Tech Note 032114_03

Product: Satellite

Subject: FI-2 Hardware Revisions

Note: Controller Improvements

FI2-B Rev2.0

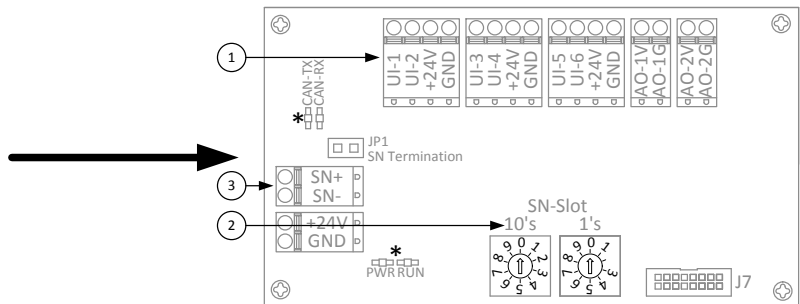
1. Universal Input Terminal Block:
 - Standardized Input, Ground, and 24VDC terminations to be adjacent.
2. Added second rotary dial to support future expansion of Satellite/Station Network addresses.
3. Satellite/Station Network:
 - Revised for standardization across product line.
